ADDENDUM NUMBER 001

DATE: March 7, 2025

PROJECT: Jonesboro Municipal Airport Terminal
OWNER: Jonesboro Municipal Airport Commission
ARCHITECT: Cooper Mixon Architects, PLLC

1 REFLECTED CEILING PLAN
1/8\"/>

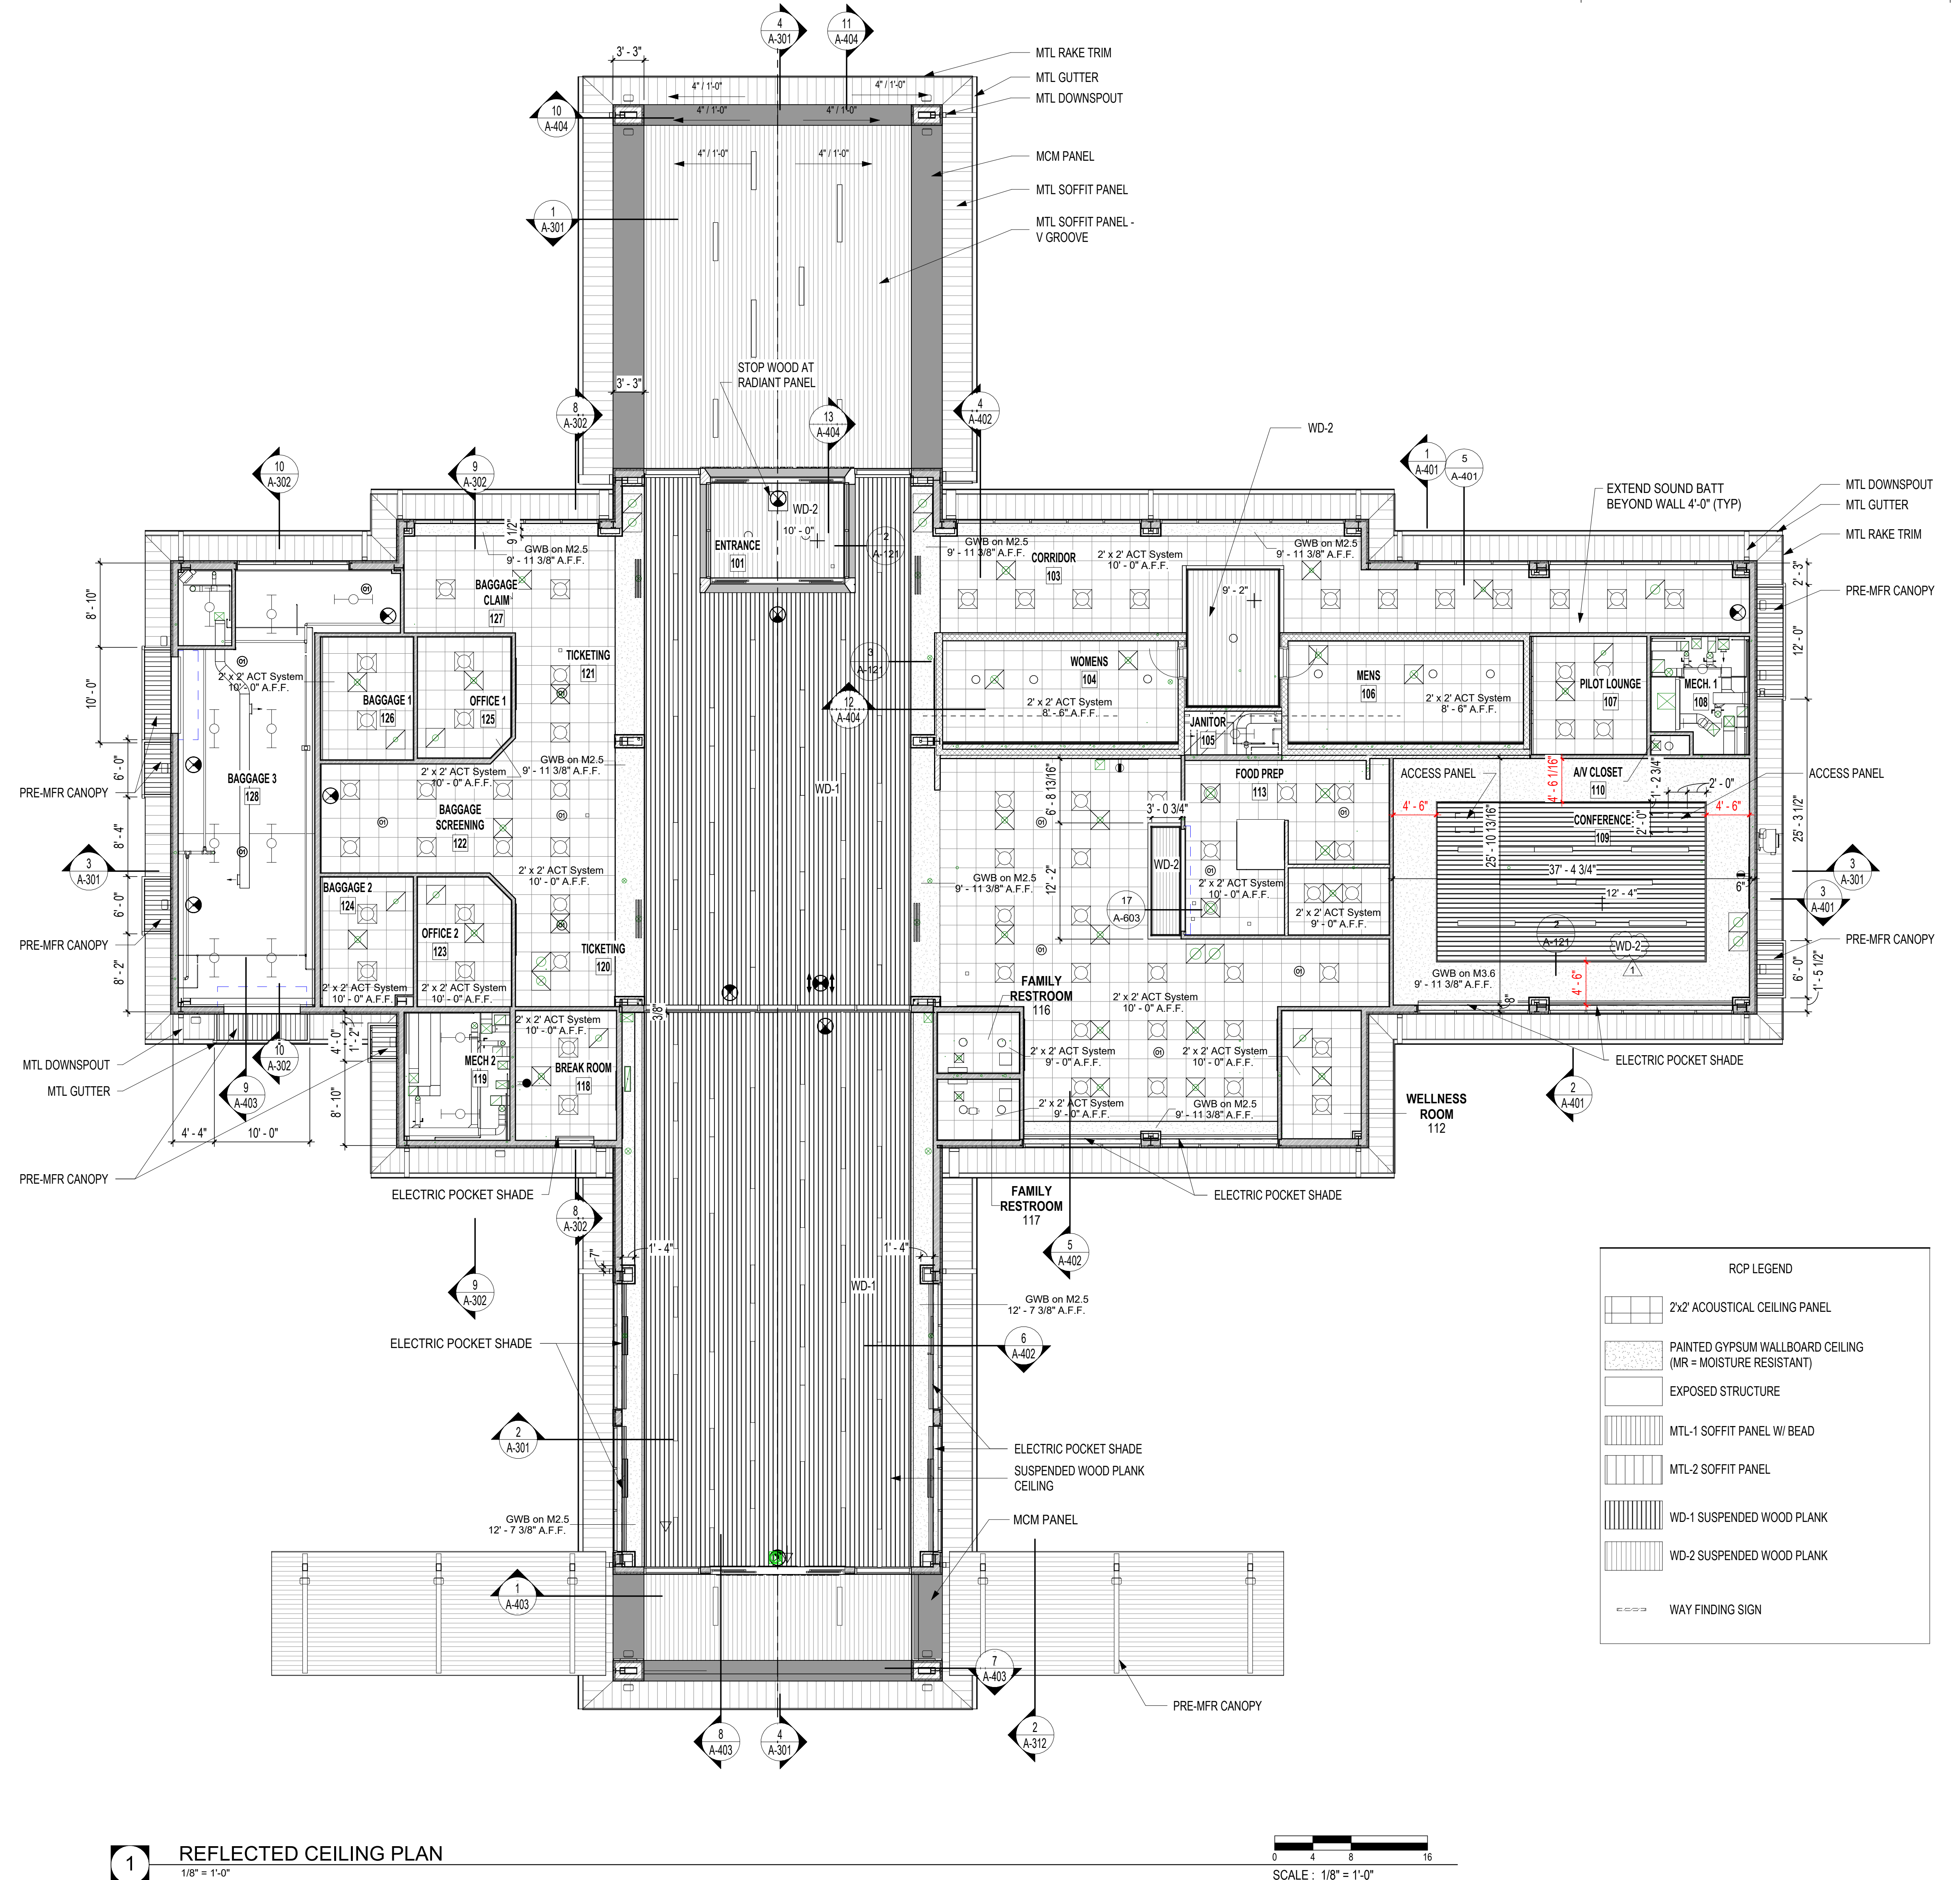
PB RFI 1	Answered	Wood Ceilings	For clarity, will the 2300 ceiling be used in the conference room? I ask because the RCP has the conference room tagged as WD-1 (2300 Continuous Linear), but the finish schedule notes that the ceiling in the conference room should be WD-2 (2400 Tongue and Groove System)	Finish Schedule is correct. Conference room receives WD-2. Refer to drawing revised in Addendum 001.
PB RFI 2	Answered	Suspension and Debarment Name Change	Is it ok to scratch through the City of Brookland and write in Jonesboro Airport on the attached (2) forms?	No. Please use the revised Suspension and Debarment document issued in Addendum 001.
PB RFI 3	Answered	Builder's Risk	Is Airport providing Builder's Risk?	Contractor is responsible for Builder's Risk. See 005200 – Agreement Form – AIA Exhibit A - A.3.3.2.1.
PB RFI 4	Answered	Concrete Paving	Concrete paving : is area at apron to be considered aircraft parking? 12" vs 6"	The concrete apron on the runway side of the building is for aircraft (12"). The concrete to the baggage area is vehicular (6").

1 FINISH FLOOR PLAN EPOXY TERRAZZO
1/8" = 1'-0"

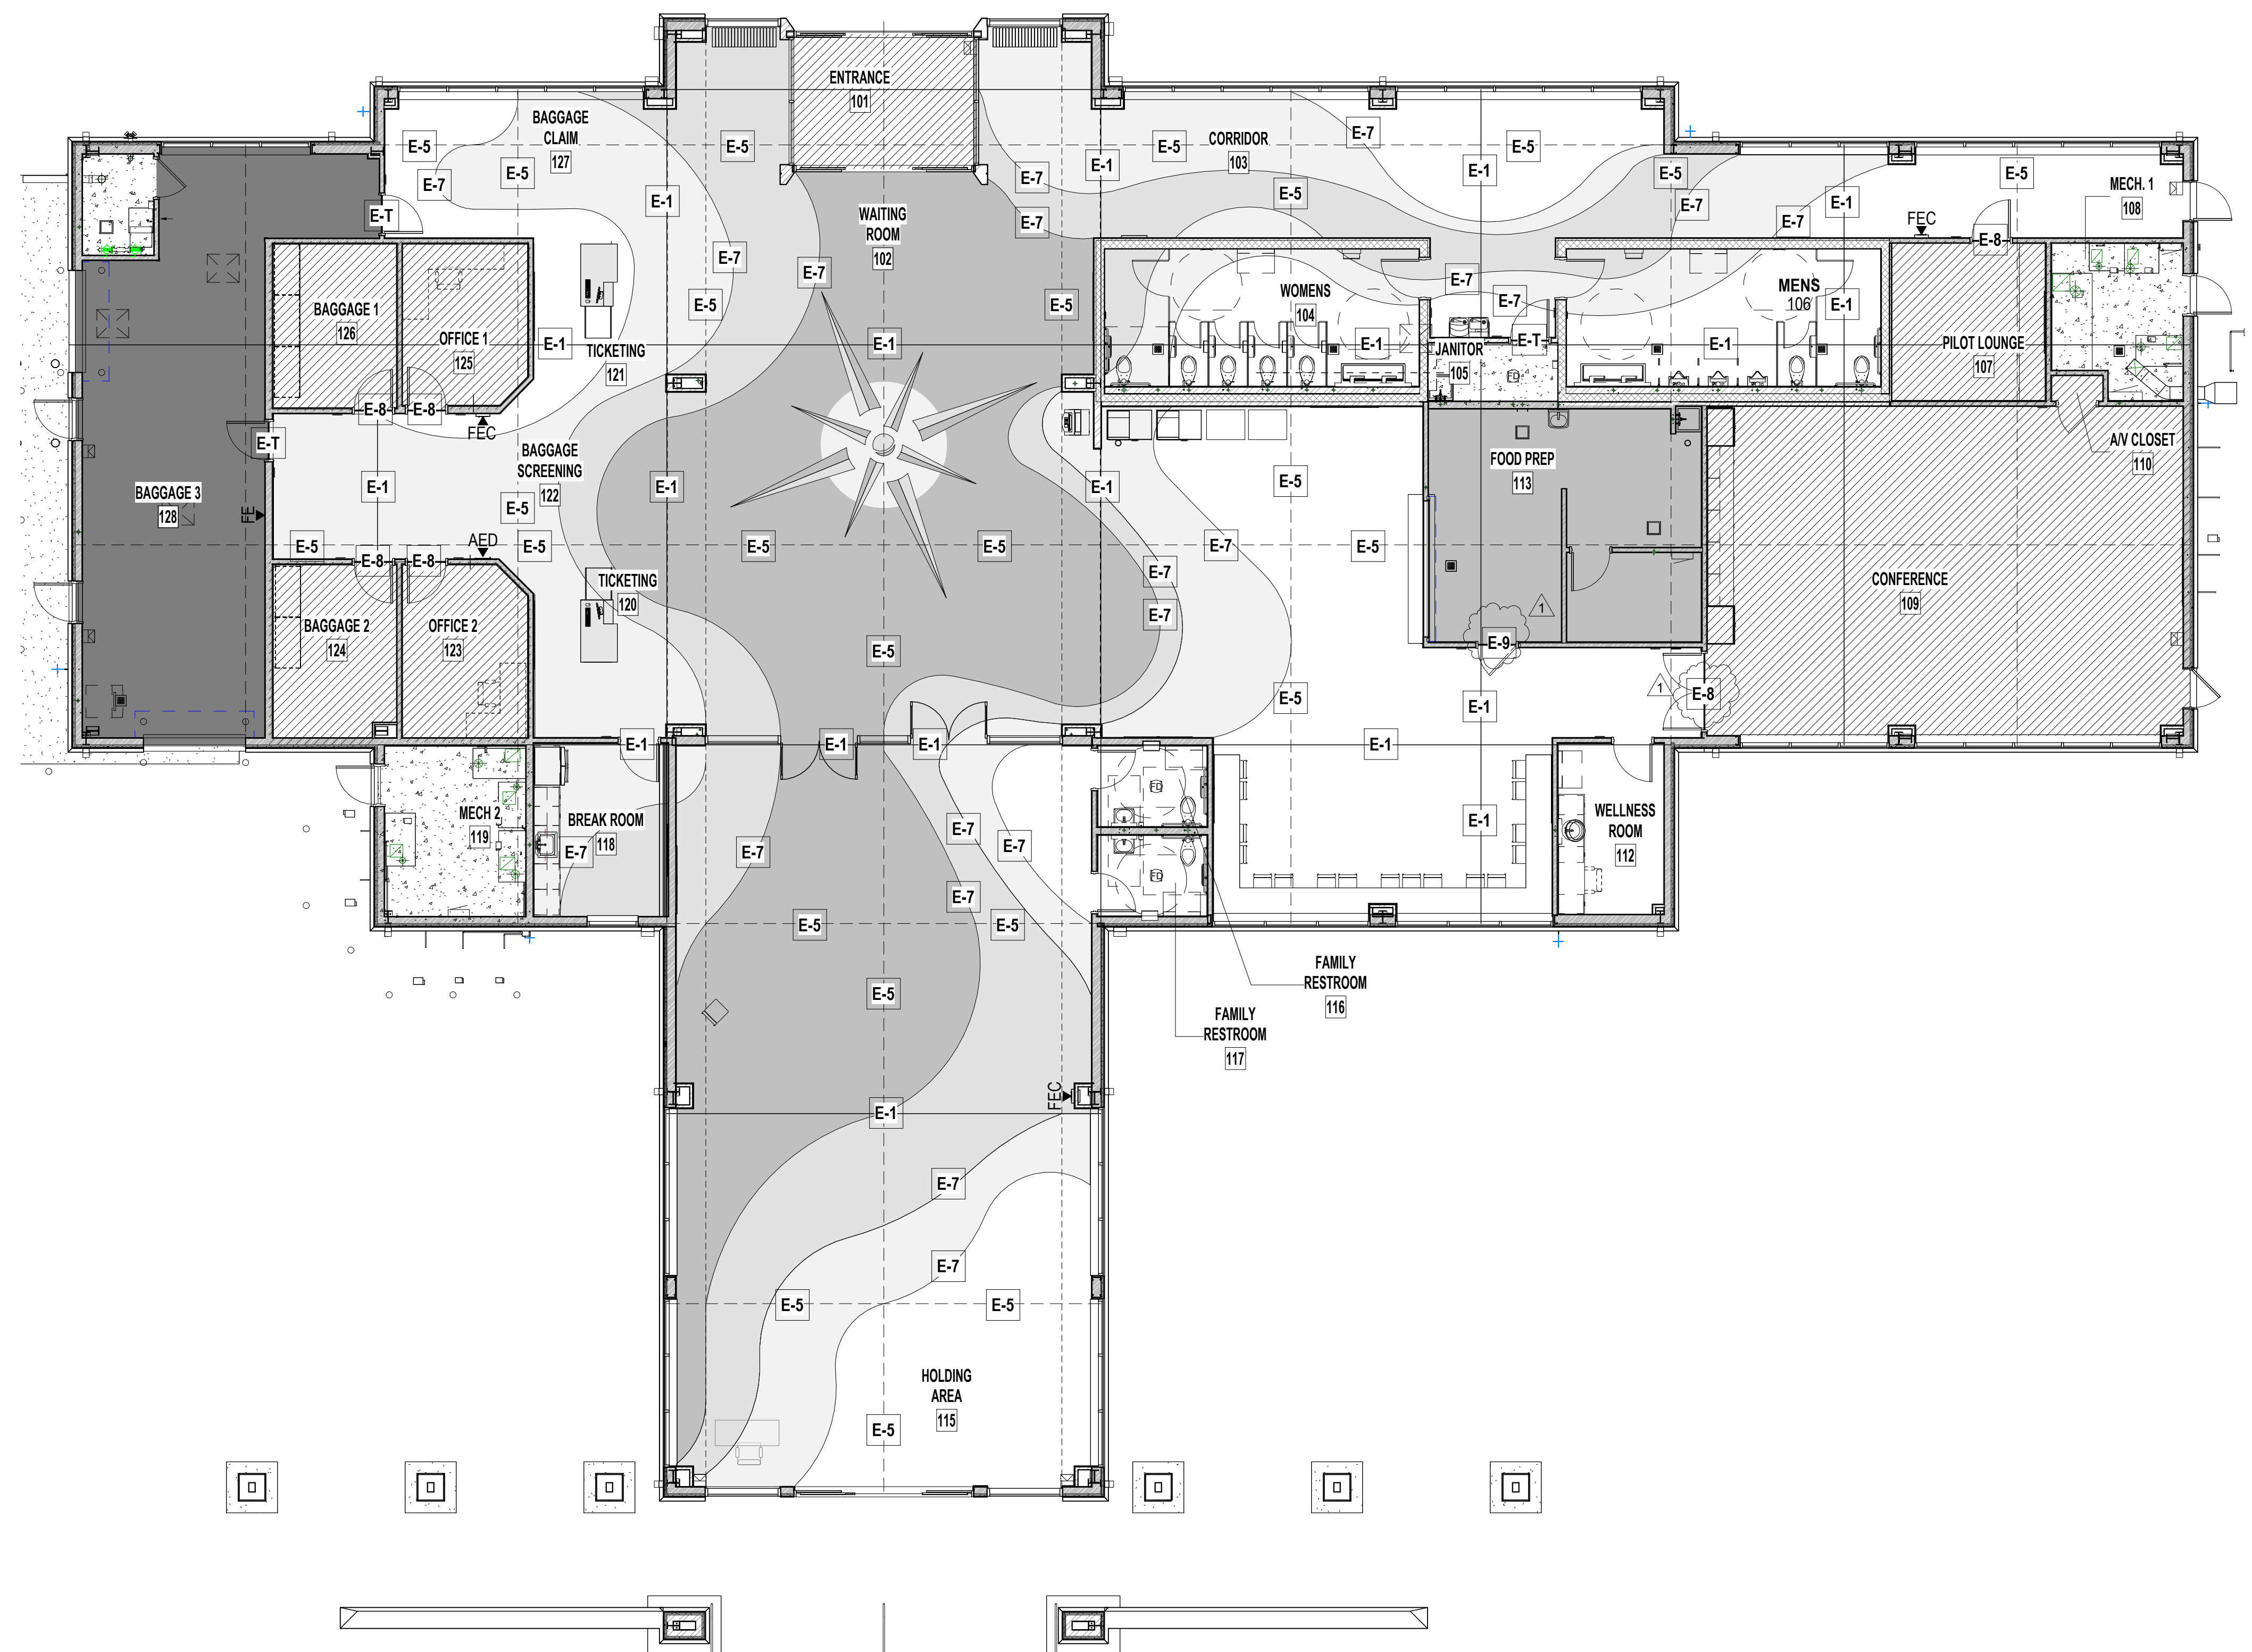
PB RFI 6	Not Answered	Exterior Signage	<p>The exterior letters are cast letters, but I am wondering if we could substitute for flat cut metal sense there is two needing bottom rail mounts.</p> <p>I also would like a little more clarification on how they want the logo mounted exactly I could not find a side detail on it</p>	Will be answered in a future addendum.
PB RFI 7	Answered	Masonry Units	<p>On the Airport Terminal Project, the masonry units called out on the plans are 16 inch by 32 inch, and the masonry units called out in the specifications is 16 inch by 24 inch, can you please confirm.</p>	Refer to the drawings for the size of the units. Units are to be 16" x 32".
PB RFI 8	Answered	Flooring	<p>Why are there two specification sections - one for Resinous Flooring and one for Epoxy Terrazzo? How do you transition between these materials at the kitchen?</p>	<p>These are two different products. Resinous Flooring is used in all the kitchen spaces. The epoxy terrazzo is use throughout the concourse and in all areas noted on the finish schedule and on A-142. See the revised sheet issued in Addendum 001 for clarification.</p>
